Sales & Service Bulletin

No. 2020/17 | November 23, 2020 | Page 1/2

DetCon2

Replacement of DenEdit Parameter file to handle 2 knock sensors at MAN E2676LE202 gas engine

Figure 1: Knock sensor positions E2676

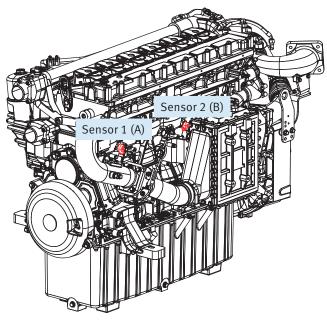
For the engine MAN E2676 gas engine series it is possible to install two knock sensors on the motor block for knock detection.

The parameter file for the DetCon2 previously delivered for this purpose will be replaced by an updated version with immediate effect. It is strongly recommended to check the file on existing installations and replace it if necessary.

New parameter file

MAN2676LE202_engine block.dep

Old parameter file

MAN2676LE202_Block-OK.dep
